**DAY ENGINEERING**

September 2, 2016

RE: City of Valdez, Alaska municipal Town water system  
SUBJ: Comments on Shannon & Wilson's elementary school well feasibility report

### Valdez aquifer drawdown in feet interpolated from Shannon & Wilson graph

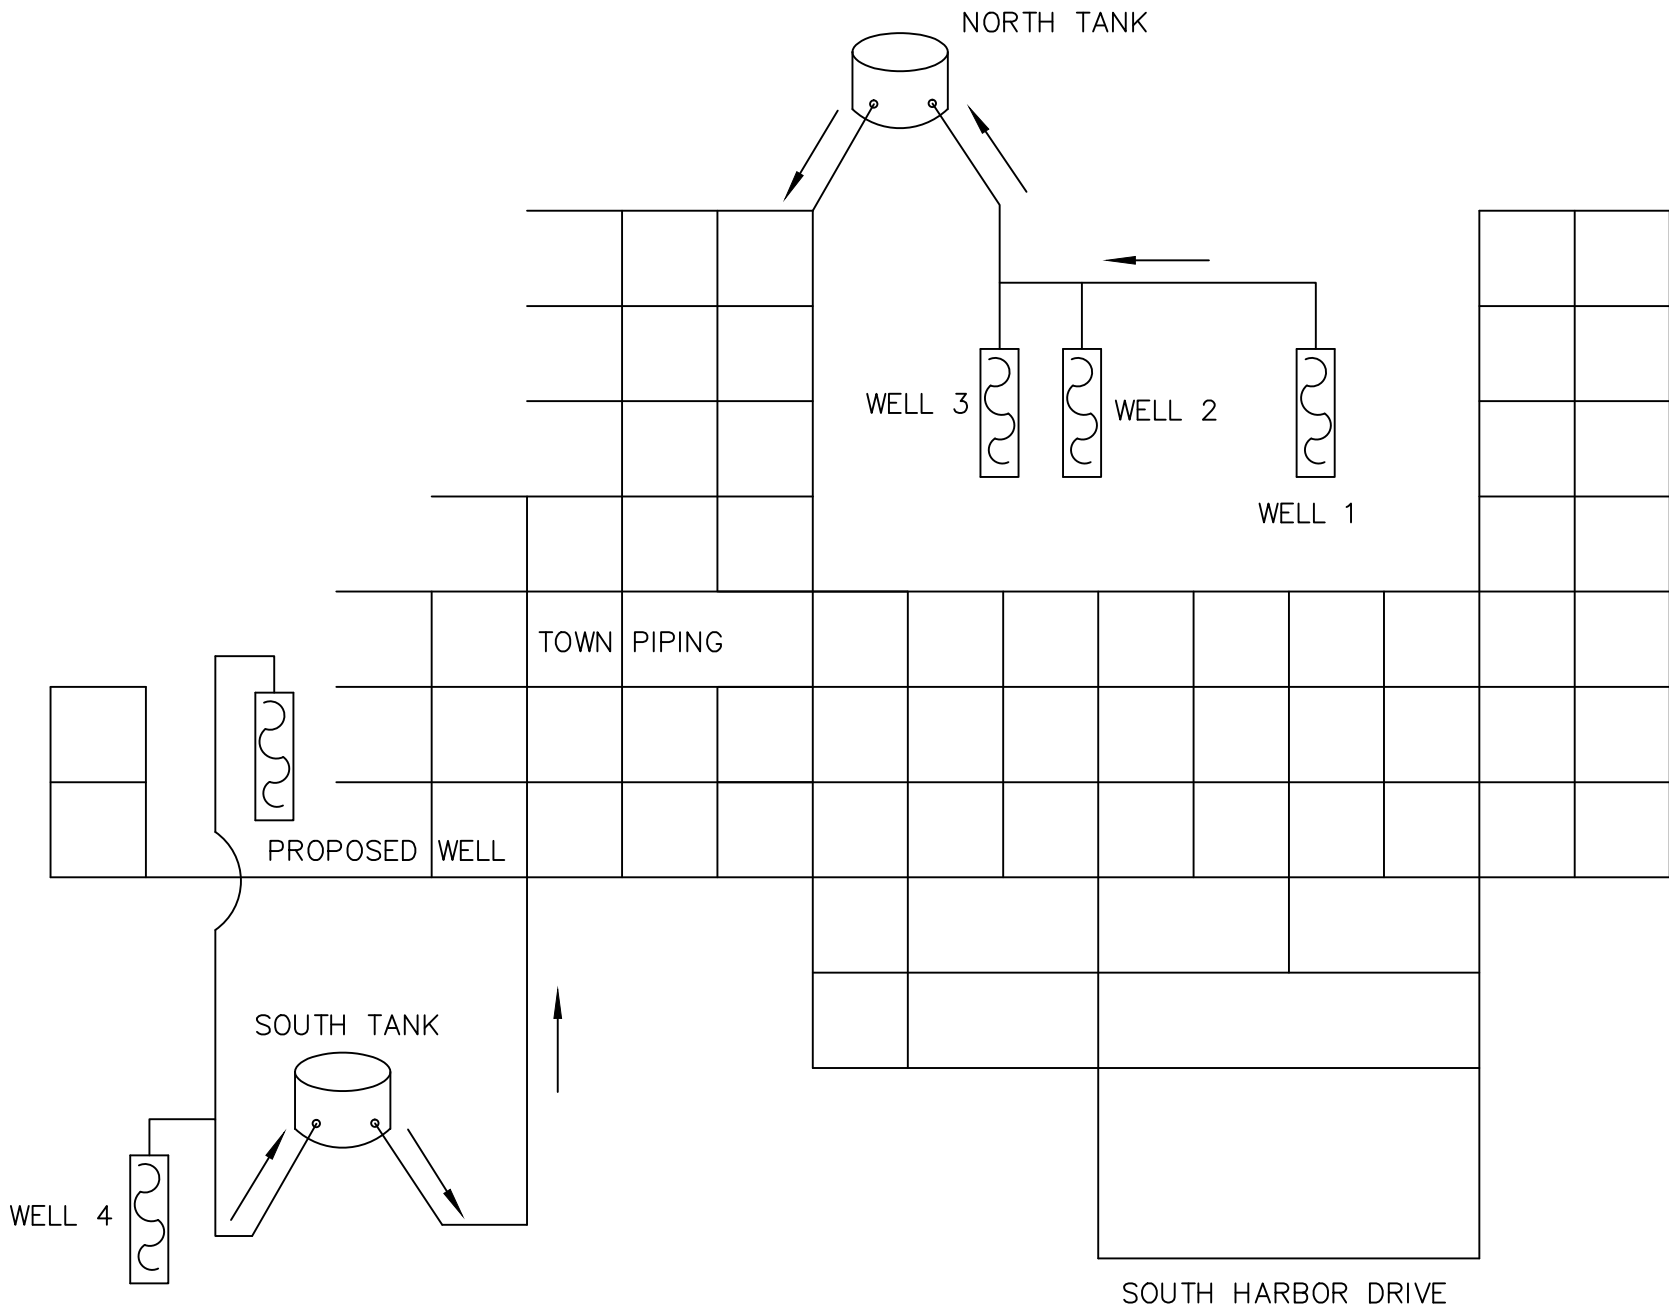
A pumping test was conducted in May of 2016 on the south well near Egan, measuring the water levels in all the piezometers as the test was conducted. The south well was pumped for 14 hours straight. The results are tabulated below:

- Valdez 2 feet contour LIDAR and Google Earth: Well 4 at 43 feet elevation (10.5 feet to water), School at 50 feet elevation (17.2 feet to water), Coho at 55 feet elevation (18.7 feet to water). Elevations are somewhat unreliable, but it's fun to look at.
